STAFF RECOMMENDATION

N. Witherell
NCPC File No. 7049

THOMAS JEFFERSON MEMORIAL PERIMETER SECURITY

Submitted by the National Park Service

East Basin Entry

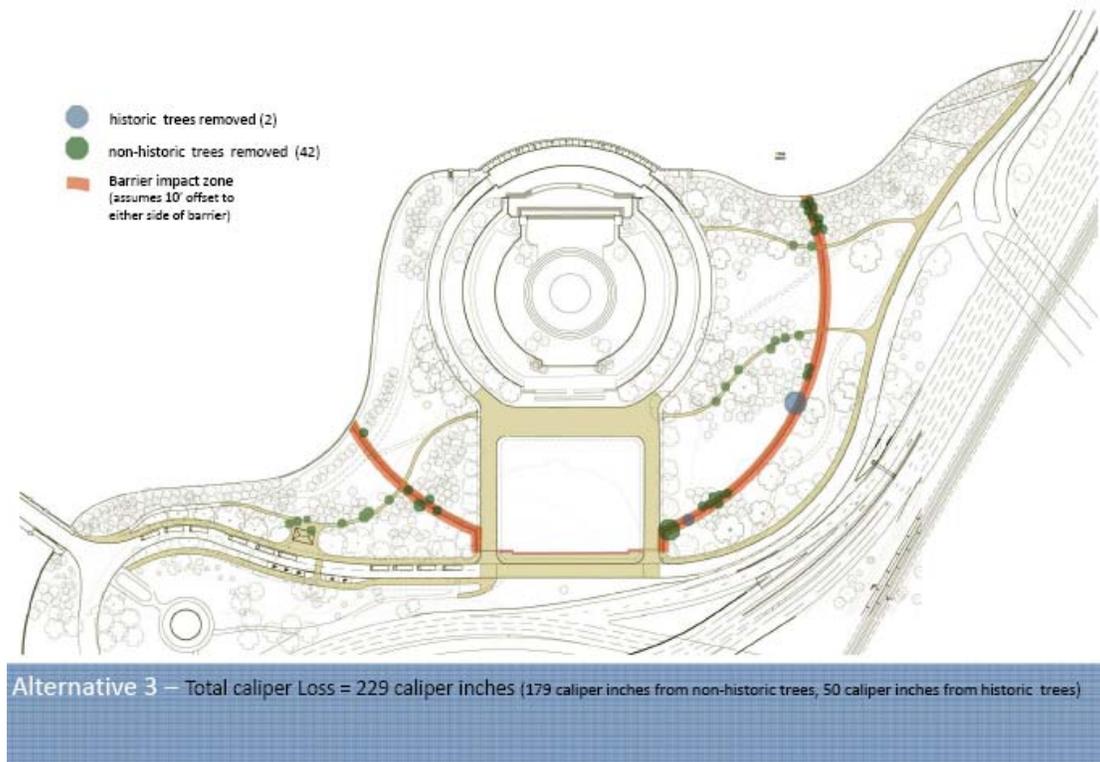
Alternative 3 seems very appealing in plan, for it has the shortest barrier line of the three alternatives and a classical simplicity. In addition, from the road it would be the least visible and visually intrusive of the three alternatives since it would be set back the farthest from East Basin Drive. Although drawing inspiration from the memorial itself, the wall's formal form and character would alter the memorial's setting very significantly, however, and be a notably foreign physical barrier throughout the naturalistic and informal landscape. It would also likely create the most prominent, visible intrusions from the Tidal Basin and Tidal Basin path, depending on the development of the wall treatment at both ends. This alternative, as with alternative 2, would require the installation of bollards across the Tidal Basin path itself.
